MEMORANDUM

TO: PLANNING COMMISSION
FROM: KEN ONDICH, PLANNING / COMMUNITY DEVELOPMENT DIRECTOR
SUBJECT: REQUEST FOR PRELIMINARY PLAT REVIEW OF STIENESSEN ADDITION CONSISTING OF 3 LOTS ON 4.1 ACRES IN THE LE SUEUR COUNTY R1, URBAN/RURAL RESIDENTIAL ZONING DISTRICT, AS PROPOSED BY BEN STIENESSEN, APPLICANT.
DATE: 6/12/24

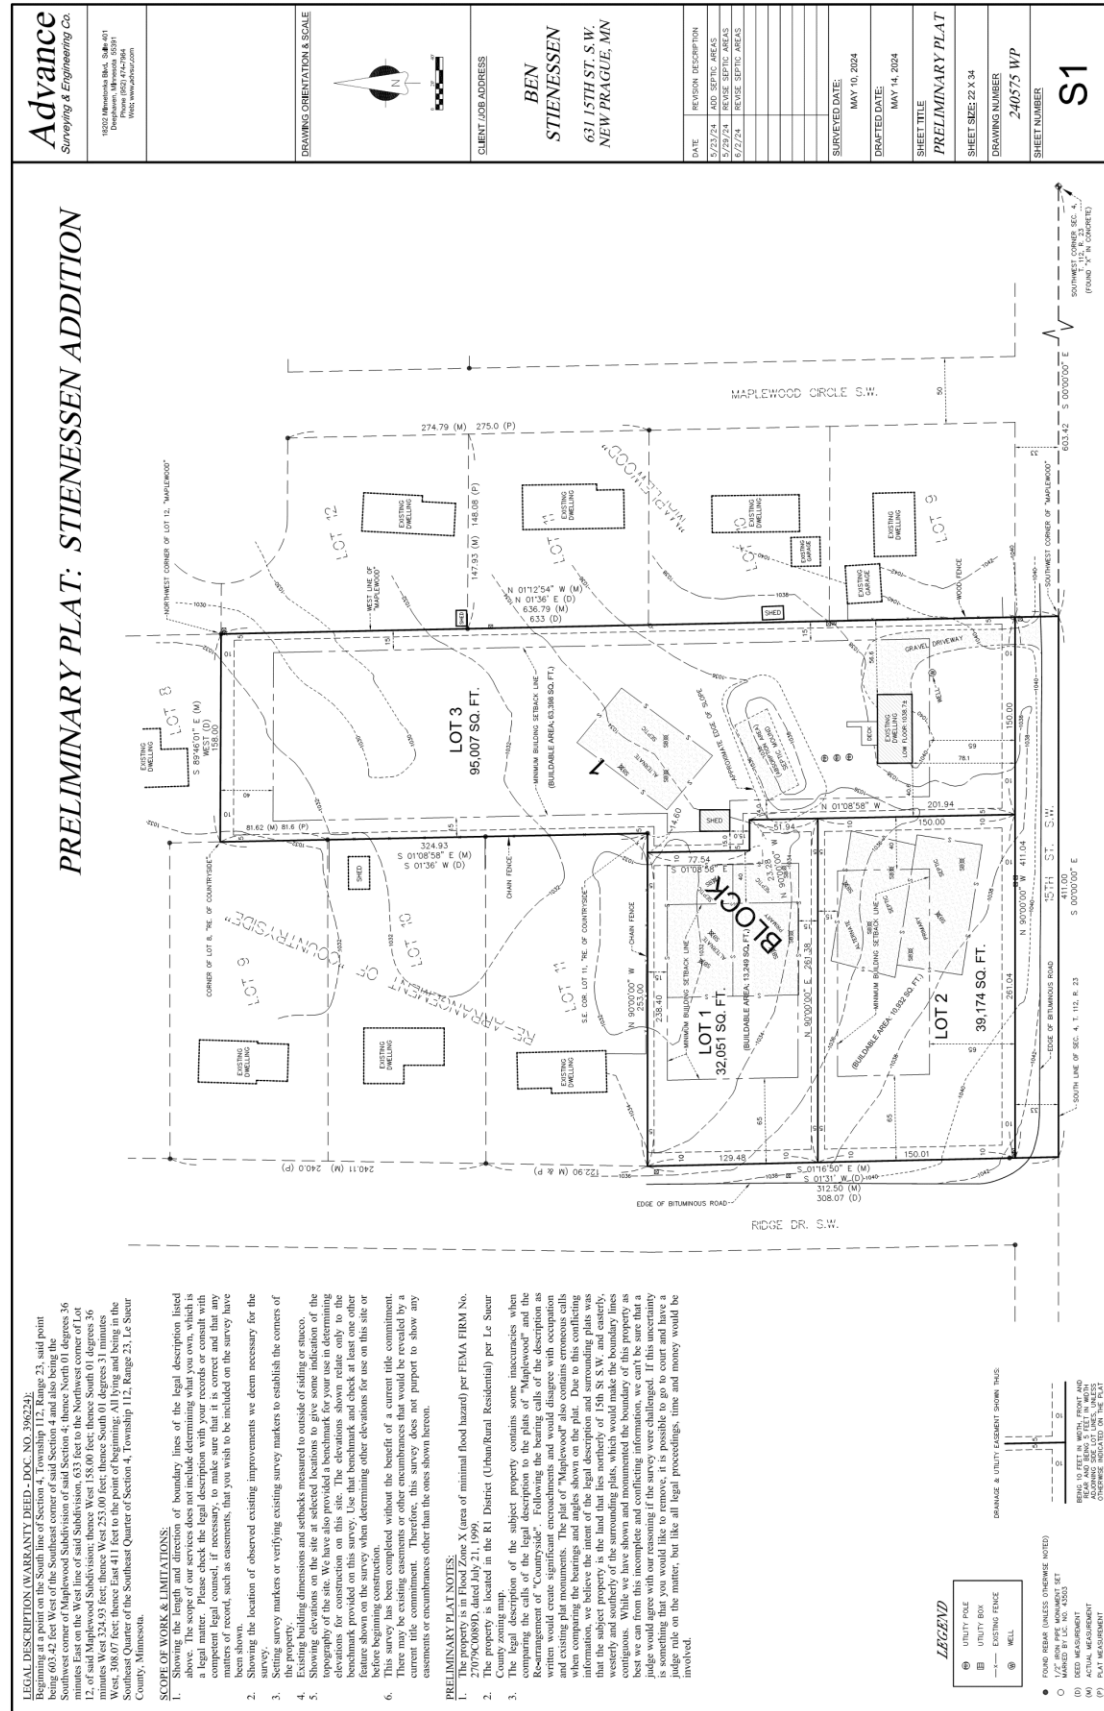
Two of the three proposed lots (Lots 1 and 2) do not meet the minimum lot requirements. Le Sueur County is reviewing variance requests for these lots at their June 20th meeting. Lot 1 requires a variance for lot width (129.48'), depth (238.40') and area (32,051 sq. ft.) while Lot 2 requires a variance for lot area (39,174 sq. ft.) only.

Access to the existing home will remain from 15th Street SW while the two new lots will be accessed from Ridge Drive SW. New driveway access will not be allowed from 15th Street SW as it is identified as a future major collector.

The proposed plat would dedicate 33’ of right of way for the existing township road known as 15th Street SW. The township agrees that this dedication is required with the plat.

1. Approval is granted in general accordance with the Preliminary Plat submittal dated 6/2/2024 on file with the New Prague Planning Department.
2. The Preliminary Plat is issued for a permit of twelve (12) months and shall become null and void without further action from the Planning Commission or City Council unless the final plat is filed within twelve (12) months of the City Council granting Preliminary Plat approval.

3. Preliminary Approval is subject to all requirements of the City Attorney including review and approval of the Title Commitment.
4. Approval is subject to all requirements of LeSueur County Planning and Zoning and Environmental Services Departments, including approval of lot size variances for proposed Lots 1 & 2.

5. A Wetlands Conservation Act “Certificate of No Loss or Exemption” must be filed prior to the final plat approval.
6. City Park Land Dedication (including a future trail segment along 15th Street SW), Saw and Seal Fee, Sidewalk Fee and Emergency Warning Siren Fee and city utility area charges and connection fees are being delayed until the time at which the property is annexed to the City and at the rates applicable at that time.

7. No new driveway access to 15th Street SW will be permitted as it is a future major collector road.
